DEVELOPMENT DETERMINATION PANEL MEETING

WEDNESDAY 19 FEBRUARY 2020

Agenda for a Meeting of the Development Determination Panel to be held on Wednesday 19 February 2020

ITEM 3.1	MOD2019/0532 - 7 HIGHVIEW AVENUE, QUEENSCLIFF - MODIFICATION OF DEVELOPMENT CONSENT DA2019/0056 GRANTED FOR DEMOLITION WORKS AND CONSTRUCTION OF A DWELLING HOUSE
REPORTING MANAGER	RODNEY PIGGOTT
TRIM FILE REF	2020/083413
ATTACHMENTS	1 ↓ DDP Assessment Report 2 ↓ Site and Elevation Plan

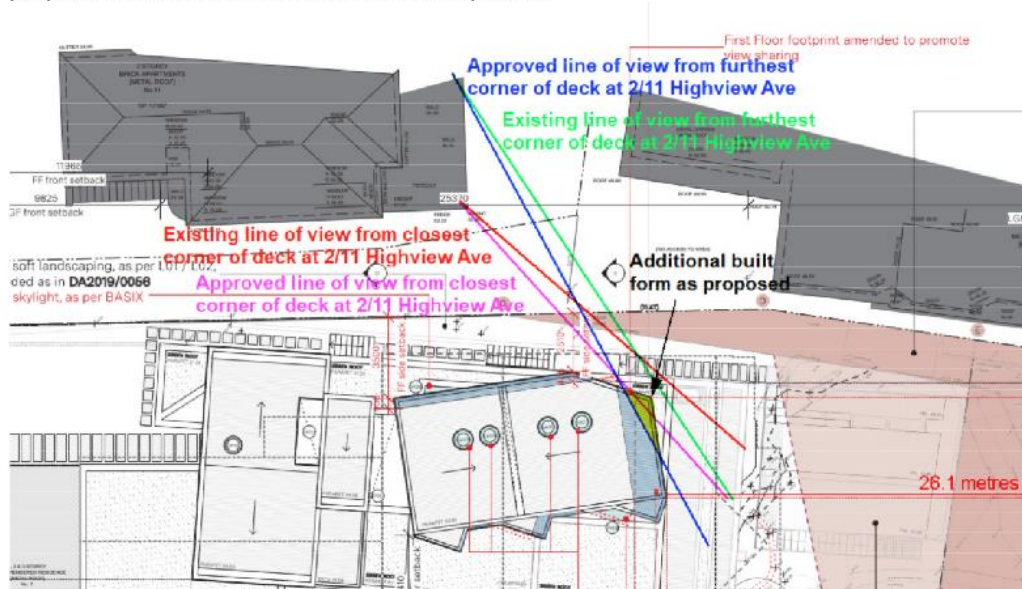
Views obtained from Nos. 2/11 and 2/13 Highview Avenue are obtained over side boundaries, from their respective decks in both standing and seated positions.

The affected view from 2/11 Highview Avenue is gained from the principal private open space (deck), so is a valued view. The proposed modification to the first floor results in a minor increase to the approved built form, as indicated in the diagram below by the pink and blue lines, and the yellow highlighted portion. However, this built form still presents an improvement on the view corridor from the existing scenario, as demonstrated by the red and green lines, as the modified new first floor is set further back than the existing floor. Further, the impacted

portion of view is of reduced importance, as it is predominantly towards existing large buildings that disrupt the ocean views (as shown above). As such, the view lost as a result of the proposed modifications is minor and acceptable.

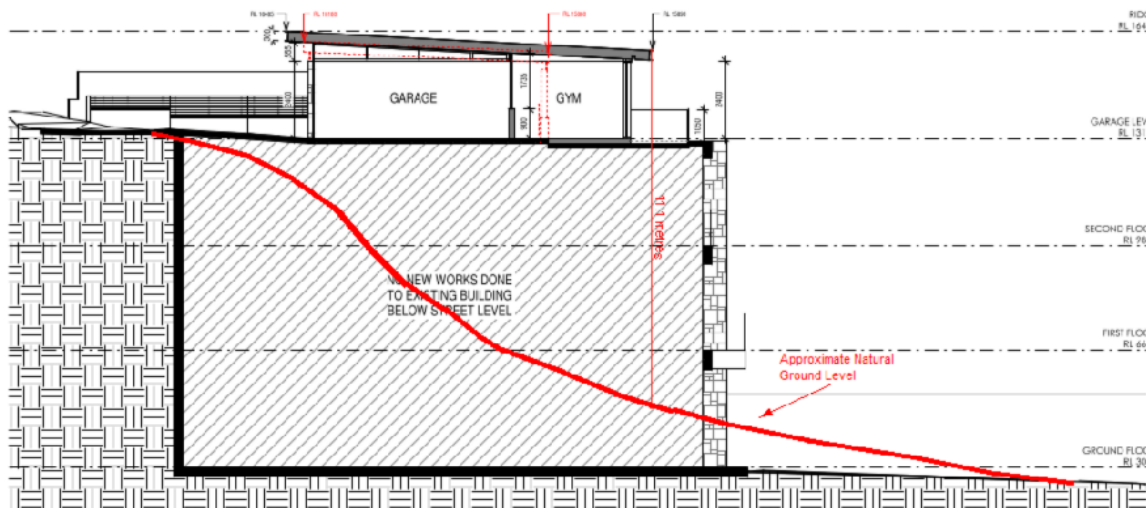
Development standard:	Height of Buildings
Requirement:	8.5m
Proposed:	11.1m
Percentage variation to requirement:	30.5%

Figure 1. Non-compliant building height shown above the blue line.

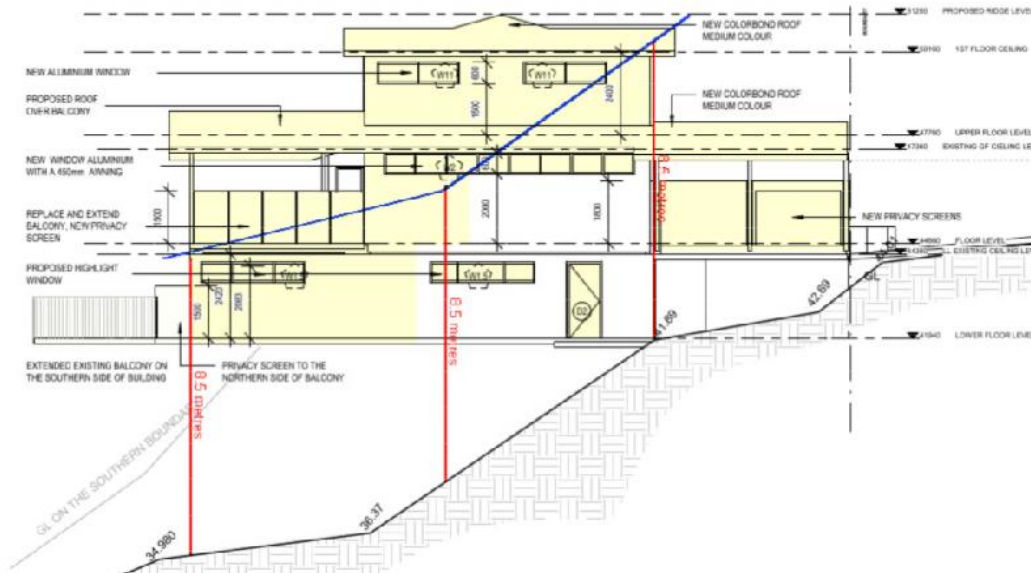
The proposed majority of the building height variation occurs at the north eastern corner corresponding to the sloping topography, as shown in Figure 1. below.

Figure 2. Compliant built form on the southern elevation.

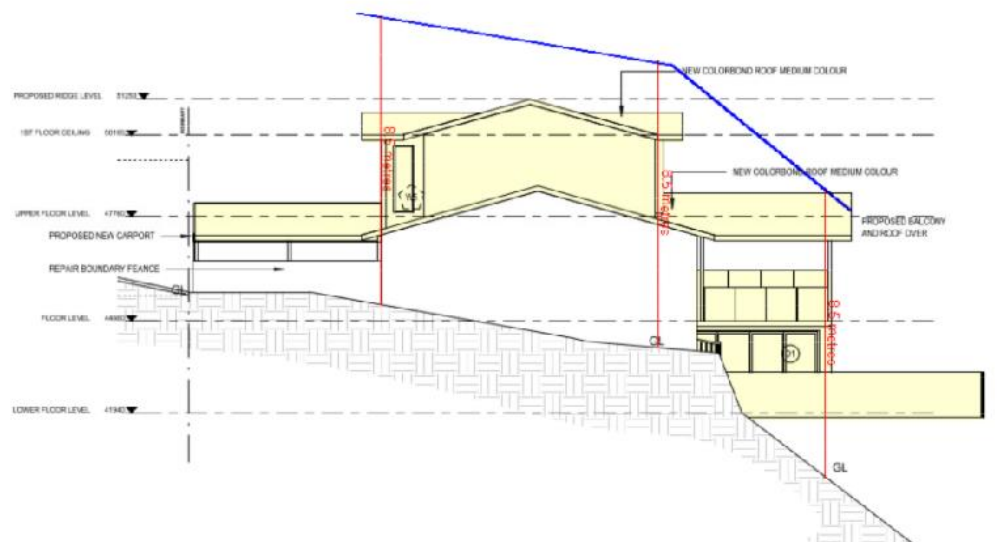
It is important to note that the building height complies on the southern elevation, due to the lower gradient of the topography of the site, as shown in Figure 2. below.

Figure 4. The proposed building envelope non-compliance shown in green, existing non-compliance shown in blue.

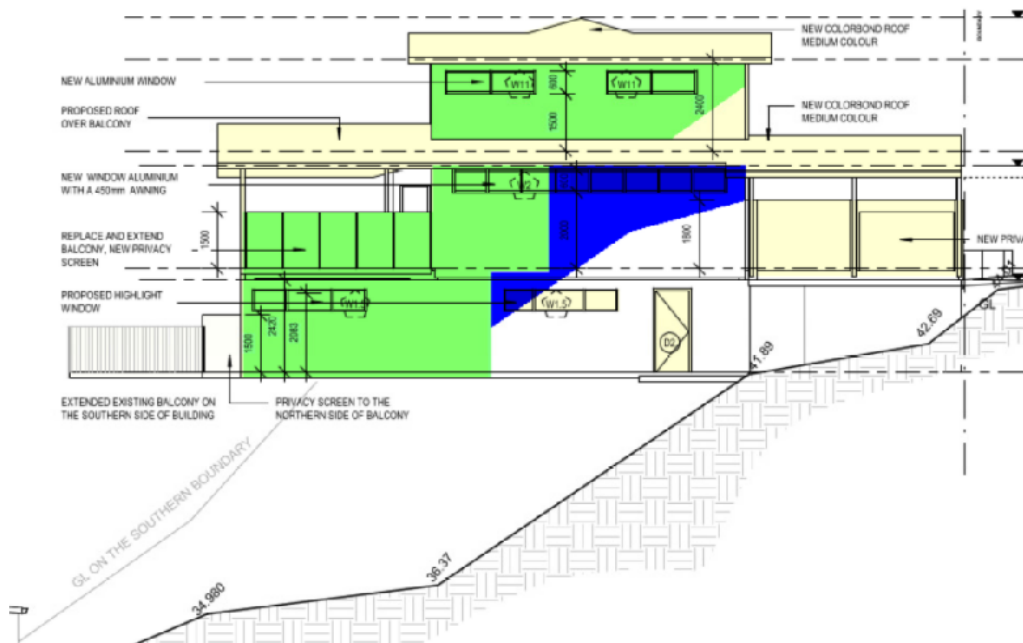
The existing and additional side boundary envelope breaches on the northern elevation are highlighted below.

As shown in figure 4 above, the non-compliant areas on the northern elevation vary in extent as a direct result of the very steep sloping topography of the site.

Photo 4. View lines to be impacted from bedroom 2 by the proposed Lower Ground Floor (note: smoke levels were high and filtered the view) for the photo.

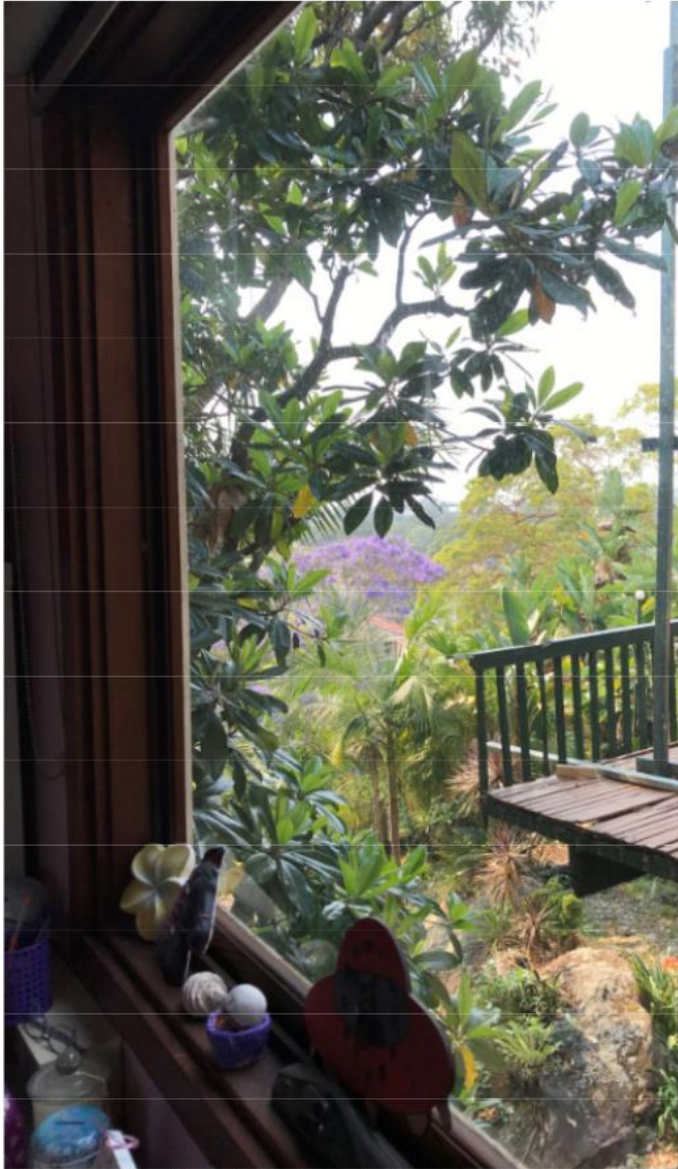
- Outdoor Rear Deck Areas - Negligible - **Minor**
- Primary Living Room - Negligible - **Minor**
- Secondary Living Room - Negligible - **Minor**
- Kitchen - Negligible - **Minor**
- Bedroom two (2) - **Moderate** (*see Photo 4*)
- Bedroom three (3) - **Negligible**
- Front Entertaining Area - **Sever** (*see Photo 5*)

Photo 5. View lines from the front setback recreational area to be impacted from the proposed Lower Ground Floor (note: smoke levels were high and filtered the view for the photo).

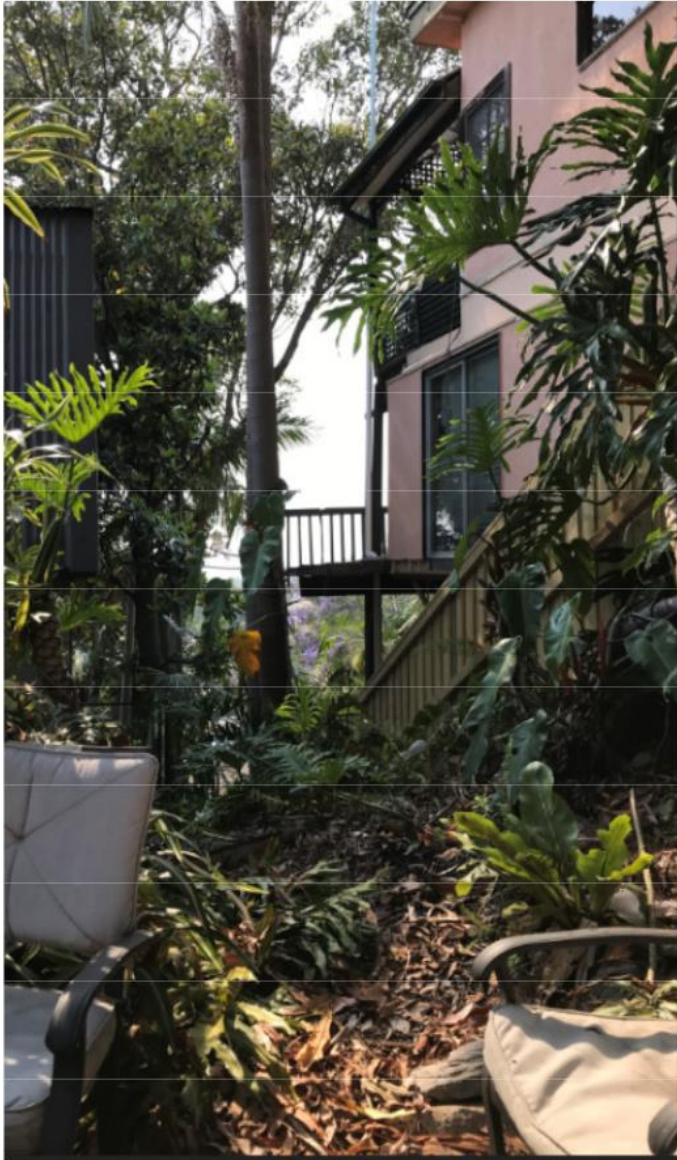
In this regard, the overall view loss is considered to be "minor", based on the only view corridor to be impacted is in a south-east direction over a side boundary, with all views over the rear and north east side boundary, including views to the significant feature of Dee Why not affected.

Figure 5. Proposed sliding gates height of 1.8m in height creating a visual "walled in" presentation to Victor Road.

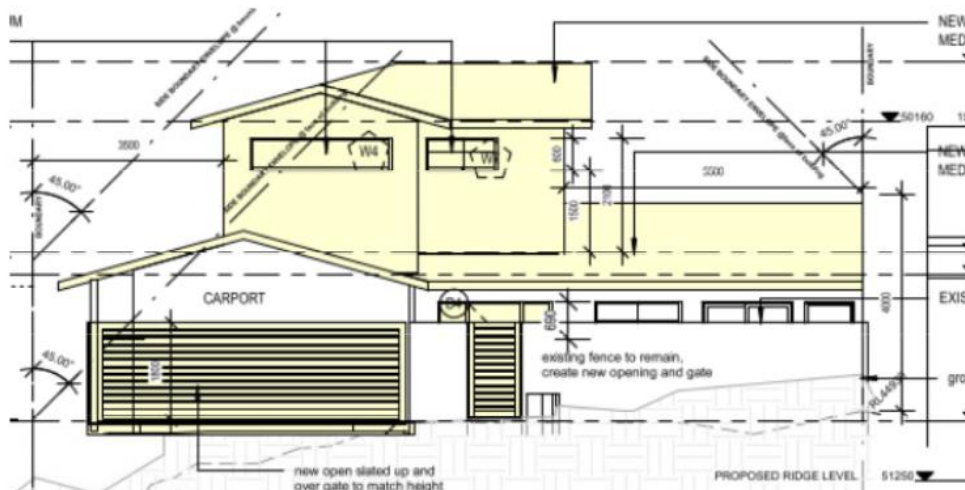
The proposed visual impact of the front fencing is mostly a 1.8m solid masonry wall and slatted gates. This creates a 'walled-in' streetscape and is not consistent with the Warringah DCP as shown in Figure 6 below.

The DCP provides a visual style guide for front fencing and in order to be consistent with the DCP it is recommended that the maximum height of the sliding gate of the carport be reduced from 1.8m to 1.65m to remove the "walled in" visual impact to the Victor Road streetscape.
